Item # 9
MCPB 01/08/04

MEMORANDUM

REVIEW TYPE: Site Plan Review
APPLYING FOR: RNC Zone; 70.50 Acres Property
32 One-Family Dwelling Units/Lots
PROJECT NAME: Meadowsweet (Farquhar Property)
CASE #: 8-04004
REVIEW BASIS: Site Plan Review Required in the RNC Zone, Article 59-D
Site Plan Review Required for reduced width tertiary street,
Subd. Rgl. 50-26(h)

B. Equestrian and Pedestrian Easement

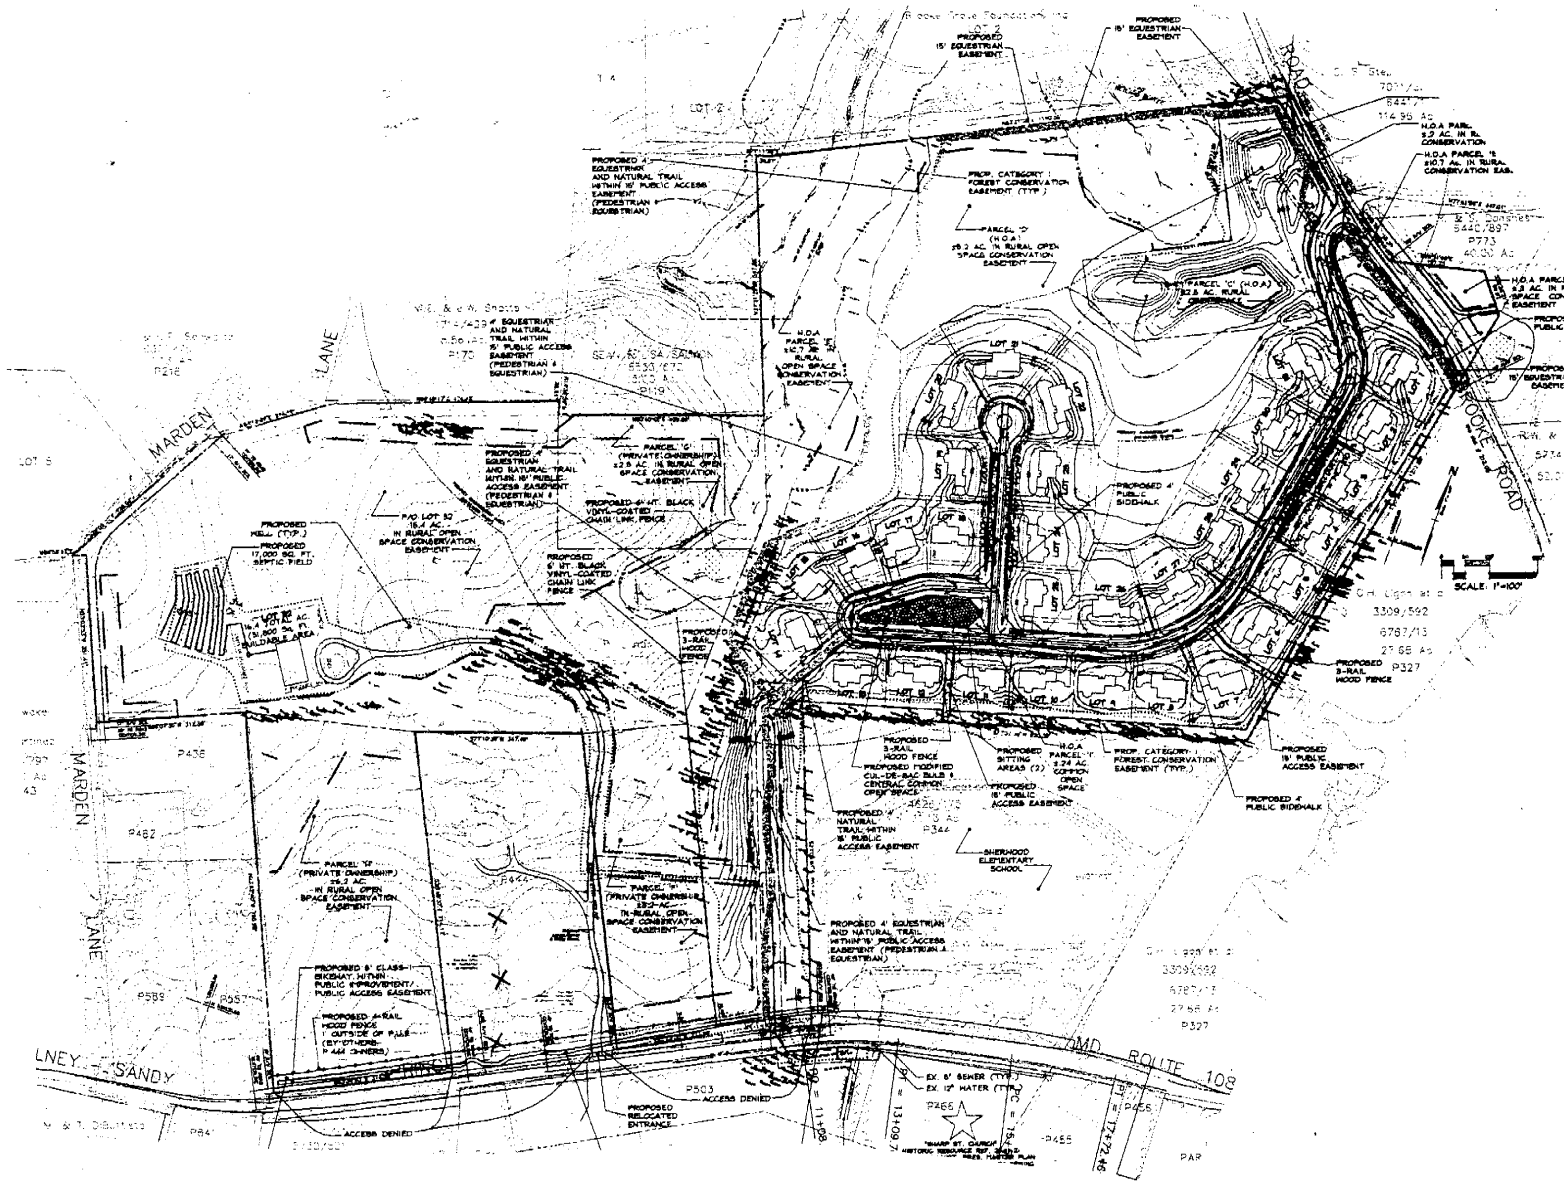
During the pre-preliminary plan review of the subdivision, concerns by neighboring property owners, the Redland Hunt Pony Club and the subject property owner were voiced with regard to existing and proposed equestrian trails through the Farquhar property. The equestrian groups proposed to keep an existing trail for horses and riders through the Farquhar property connecting Brooke Road and Marden Lane. Opposition to the requests of the equestrians came from adjacent homeowners who live on Marden Lane and the subject property owners. The existing trail apparently meanders through the property of the adjacent property owners who do not want equestrian activity in their back yard.

The applicant has proposed three easements for equestrian and pedestrian use on the property. The first easement runs north and south connecting MD 108 and the private drive for the Brooke Grove Foundation approximately halfway in the middle of the adjacent Lot 2. The applicant will provide a natural surface path in the easement for equestrian and pedestrian use. The remaining two easements will connect with other trail easements at the northern property line adjacent to Brooke Grove and along the frontage of the improved Brooke Road. The latter will only be easements.

Staff supports the location of the proposed equestrian and pedestrian easements. Equestrians will have designated easements from Brooke Road to MD 108 providing a future link to Rural Legacy Trail south of MD 108. The easement also provides access along the northern property line and the Brooke Grove Foundation. There will be no encroachment onto adjacent property and the equestrians will continue to have north south access to MD 108 and to Brooke Road.
